Re: 445-459 Canterbury Road | Campsie Private Hospital Development

Northrop Engineers have been engaged by Hailiang Property Group to provide advice regarding appropriate allowances that should be made for building services zones in the ceiling space and on the roof, as well as structural floor thicknesses, to assist in establishing floor-to-floor heights for the above development.

Figure 1: Massing Section prepared by Team2

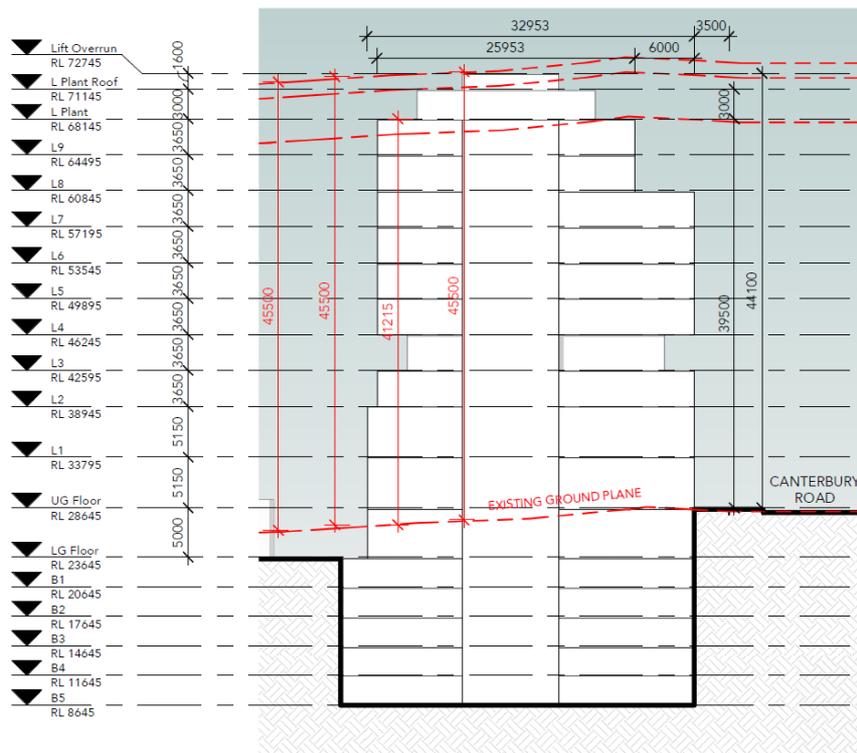
From our experience working on health projects of a similar scale, we believe the floor-to-floor heights proposed by Team2 appear reasonable. For your reference we have provided typical allowances we recommend for building services zones and structural floor thicknesses below.

- Building services including mechanical, electrical, fire, hydraulic and medical gasses typically require a zone of 1-1.2m in the ceiling space in operative theatres and other hospital spaces requiring high sterile environments including isolation rooms.
- The building structure typically consists of 250-300 deep concrete post-tensioned floor plates, supported by a column grid of approximately 8.5m. Some areas may require additional structure to resist footfall vibration for sensitive equipment.

- Building services require a zone of 750mm-1.2m to allow for medical gasses, significant mechanical ductwork and framing for equipment including bariatric hoists, curtains, etc.
- As above, the building structure typically consists of 250-300 deep concrete post-tensioned floor plates, supported by a column grid of approximately 8.5m.

- An appropriate allowance for building services plant on the roof is 3m for plant plus 1.6m above this for a single lift shaft overrun. Lift access to the roof is likely to be necessary for ongoing plant and equipment maintenance. This is shown in the Team2 concept sections and drawings.
